Waterford Group70 Ewart Ave. RR#8
Brantford, OntarioATTN: Caitlin Port, MHBC
Ed Lamb, Waterford Sand and GravelSubject: Law Quarry Extension Noise Impact Study
JART Comment Letter Responses**1 Introduction**

Law Quarry Extension - Addendum

Table A-1

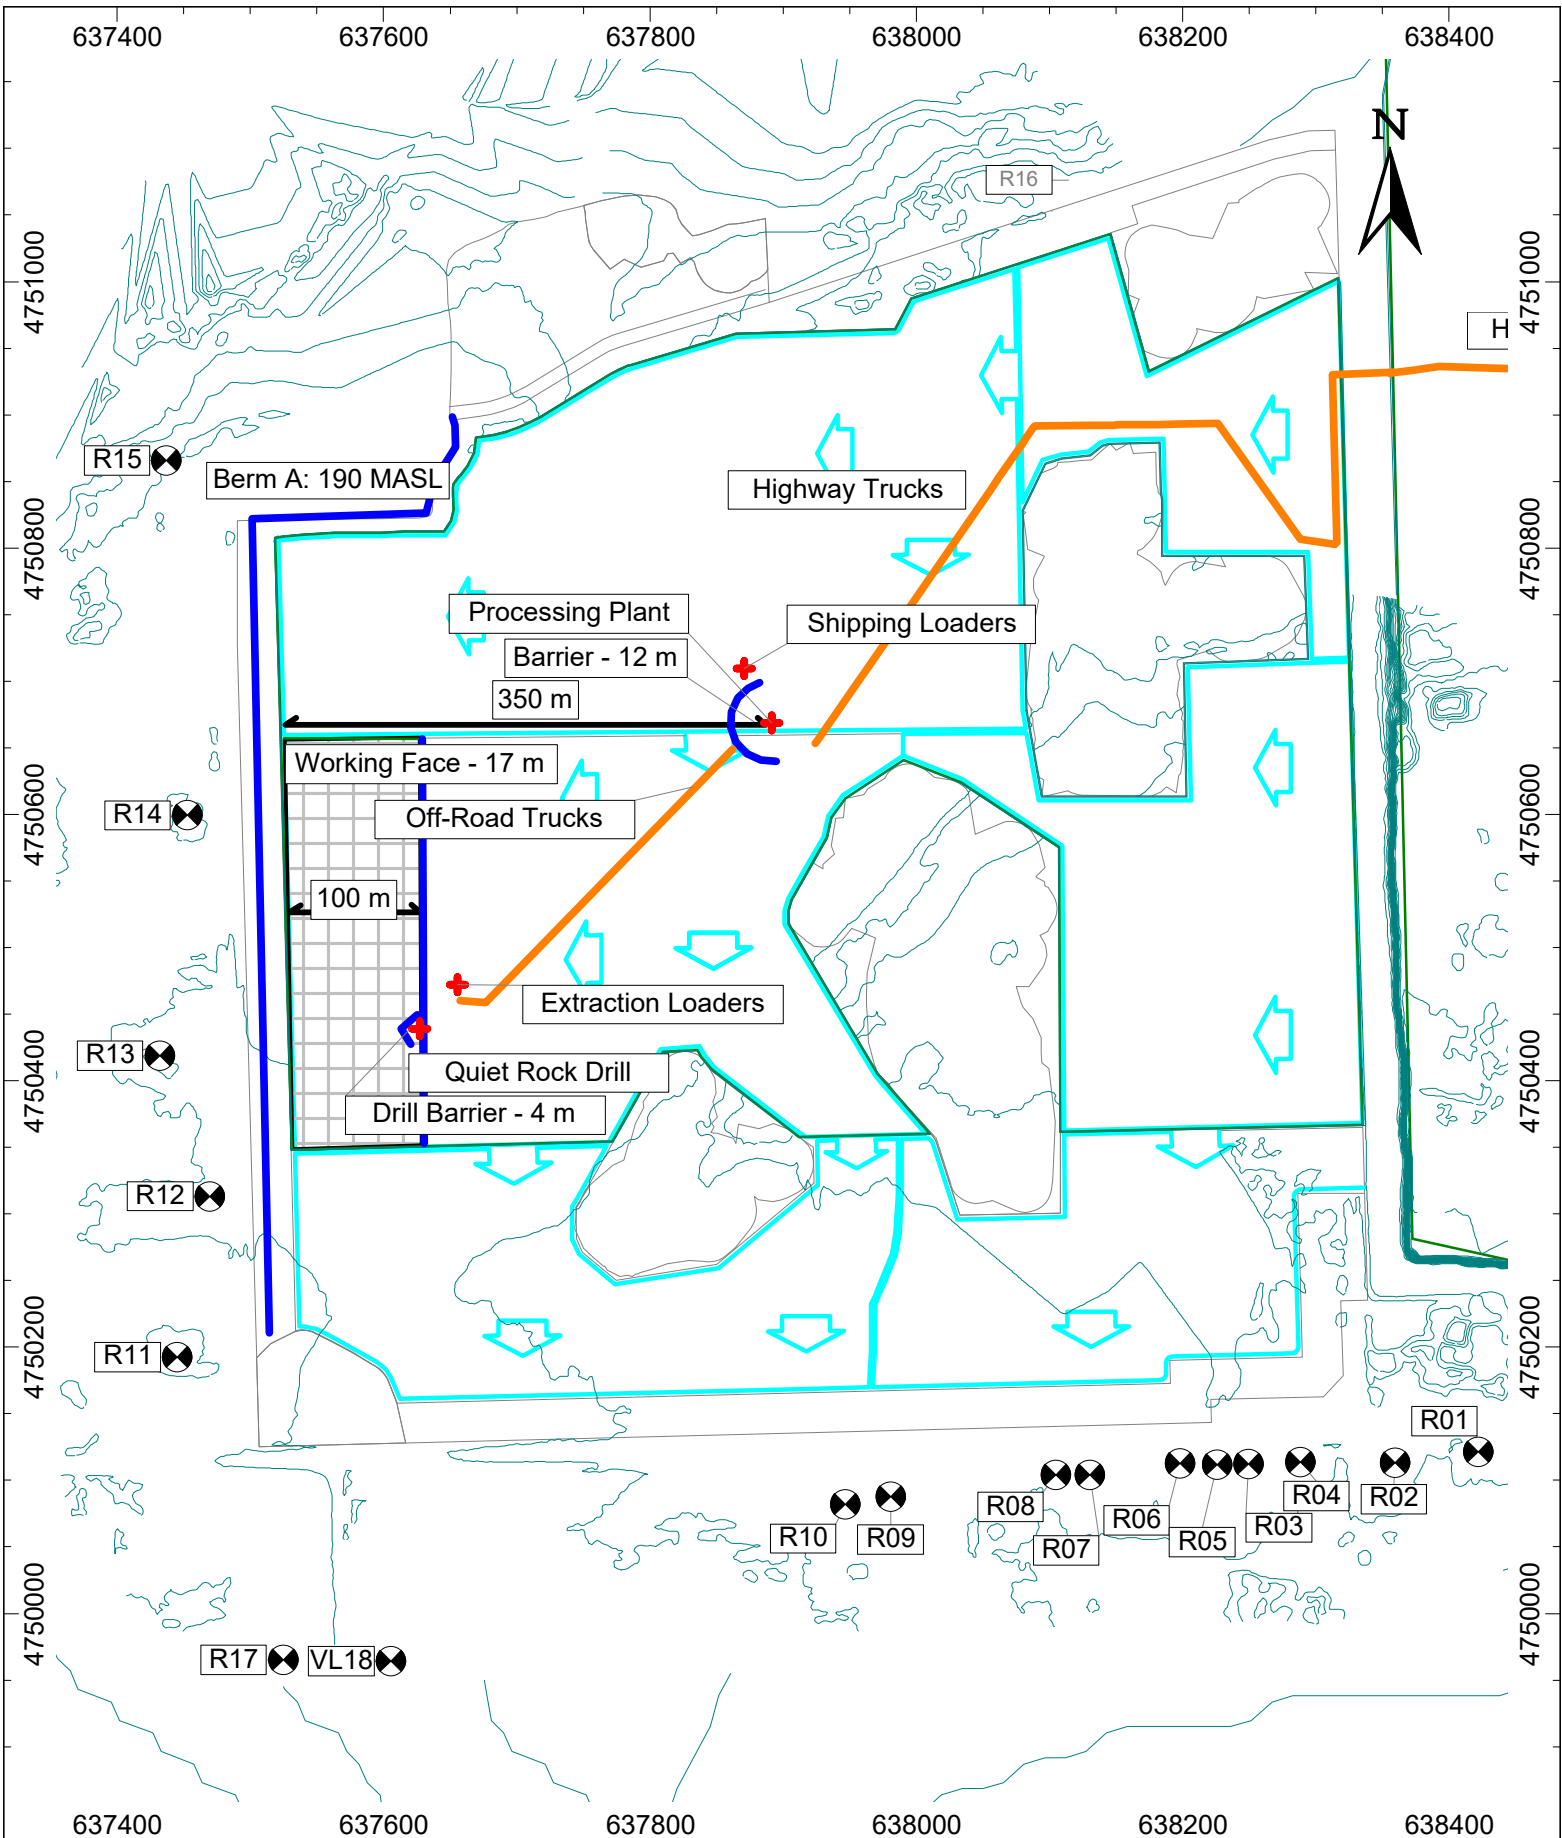
- 2. The reviewer requests clarification on the hourly distribution used for road traffic STAMSON calculations.*

A sample traffic distribution of the Institute of Transportation Engineers (ITE) was utilized and is appended to this document (Table A-1). The minimum hourly traffic count of 232 vehicles per hour were based on the lowest-volume daytime hour, representing a conservative approach. Heavy and medium trucks were assumed to represent 6% of the annual average daily traffic with a 50/50 medium/heavy distribution.

Project ID: 17132.02	Project Name Law Crushed Stone - Quarry Extension	Figure A-1
	Scale: As Indicated Drawn by: KC Reviewed by: DF Date: Feb. 2024 Revision: 2	Figure Title Noise Control Implementation - Phase 3

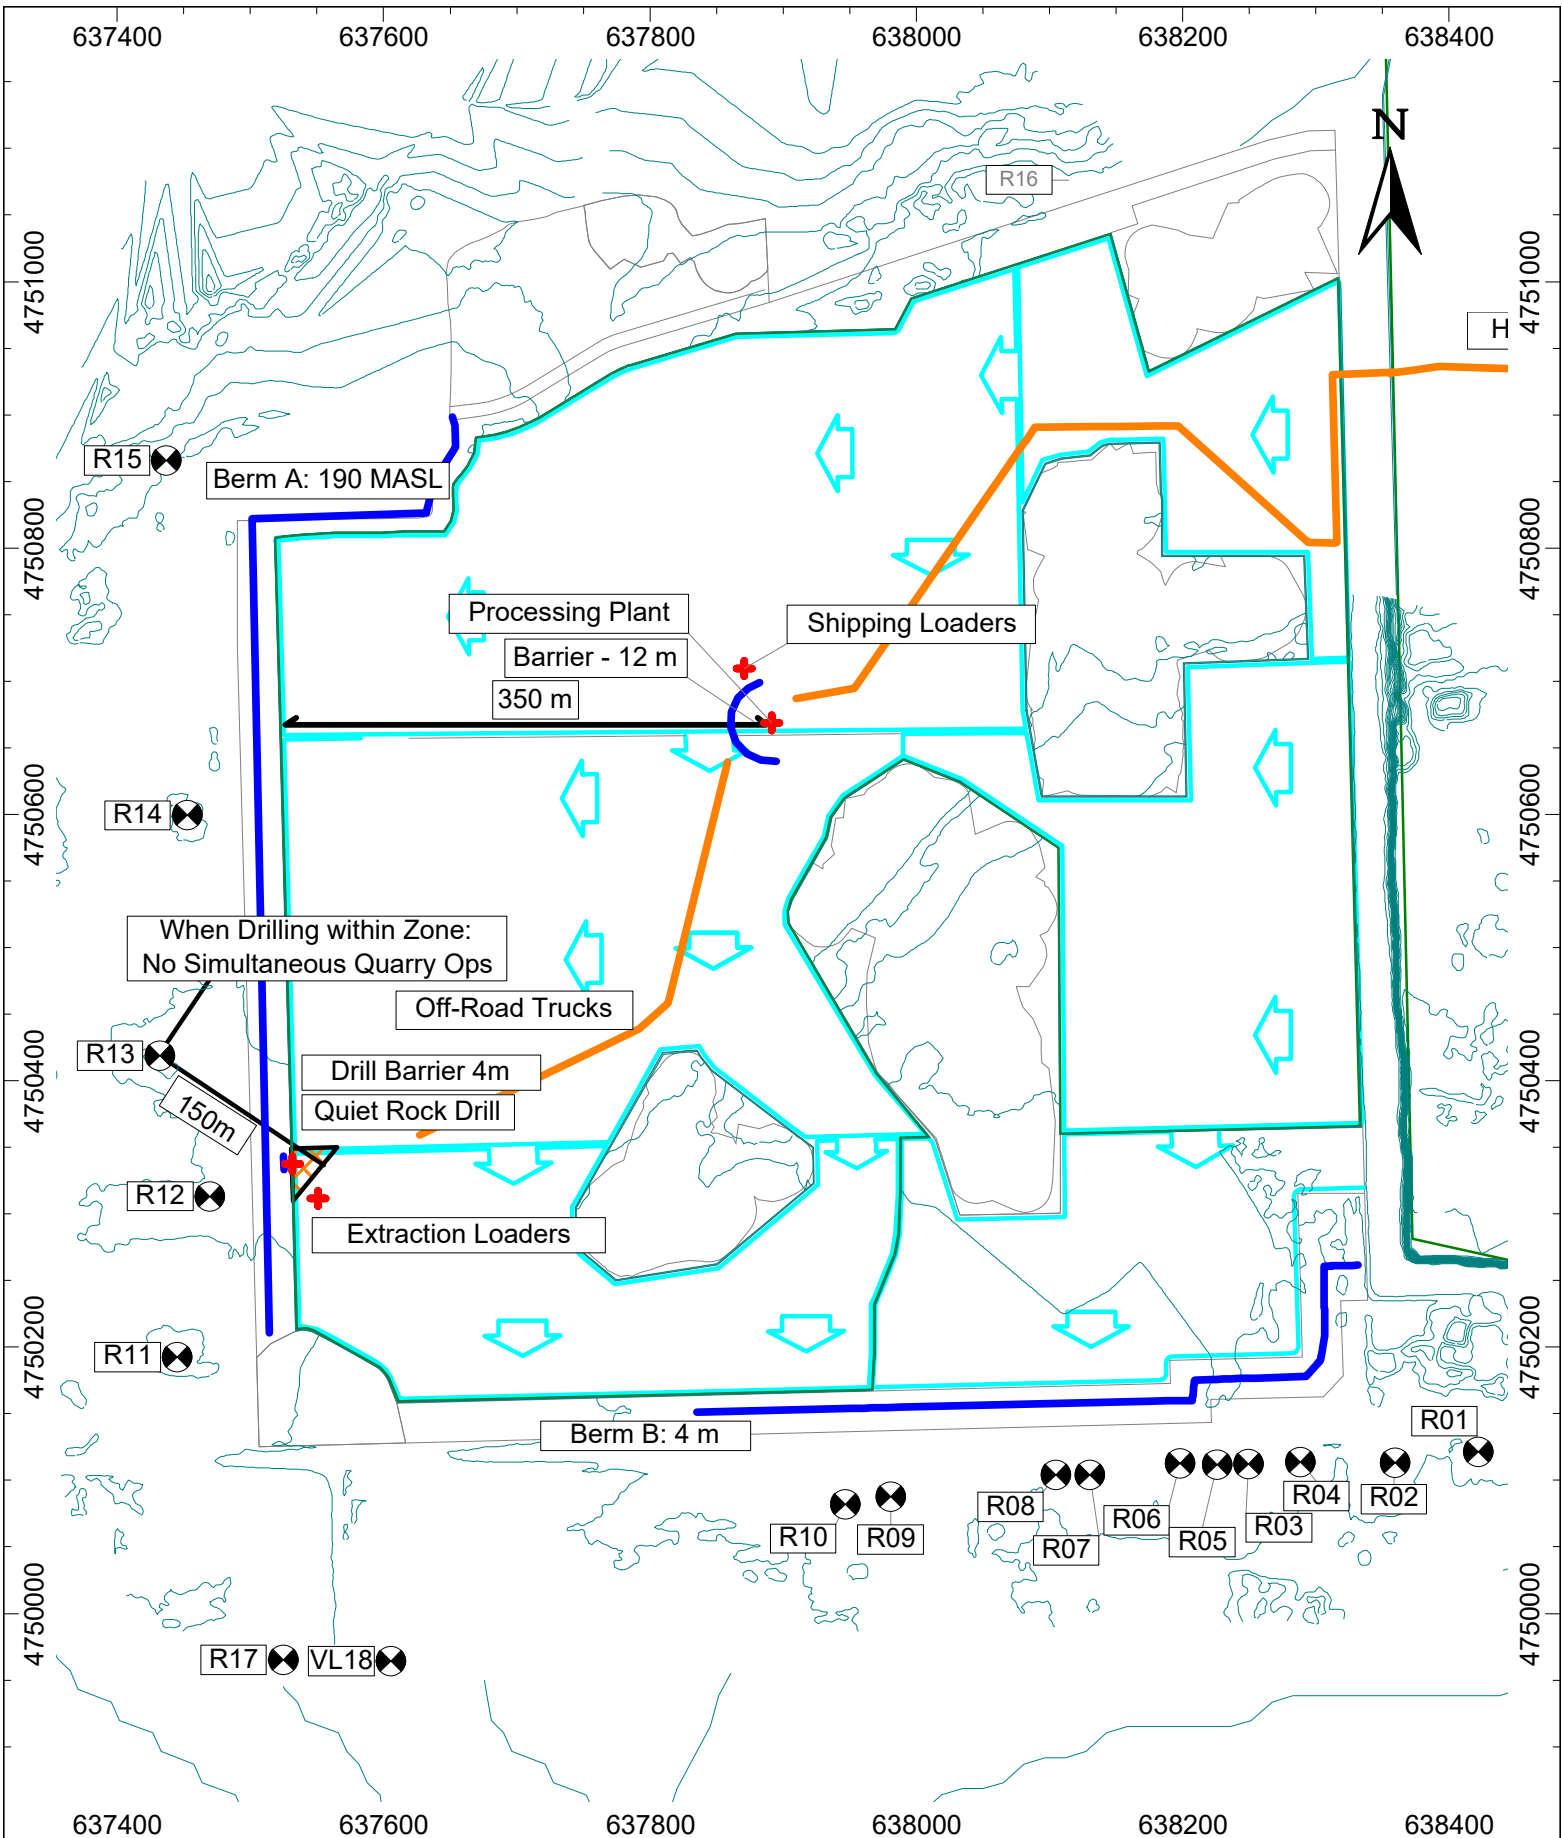
- 4. The reviewer requests that first-order acoustical reflections be considered in the analysis study.*

However, upon additional analysis, one scenario was identified wherein reflections from the Processing Plant had the potential to cause exceedances at Receptors R13 and R14. Additional modelling was carried out to evaluate the contribution of acoustical reflections across all phases of the quarry operation.

The worst-case noise impacts – including the contribution of first-order reflections – are predicted to comply with the MECP sound level limits in all operating phases and scenarios with incorporation of the following revisions to noise controls on the Operation Plan:

#14	Prior to westward extraction in Phase 3, the Processing Plant shall be located between the sections of unextracted land as shown in the Operation Plan and shall remain there for the duration of Phase 3 extraction. During processing operations in Phase 3, the line of sight to receptors R11 to R15 shall be broken by either: <ul style="list-style-type: none"> A) An acoustic barrier with a minimum height of 12 m within 30 m of the Processing plant; or B) Intervening unextracted land with a minimum height of 17 m within 60 m of the Processing Plant. 	During extraction operations in Phase 3, the Processing Plant shall be prohibited from operating in the Phase 3 area and shall not operate within 350 m of the western extraction limit. The line of sight between the Processing Plant and any of Receptors R11 to R15 shall be broken by an acoustic barrier with a minimum height of 12 m within 30 m of the Processing Plant

These changes will be reflected on a revised Operation Plan and are illustrated in the appended Figures A-1 and A-2.
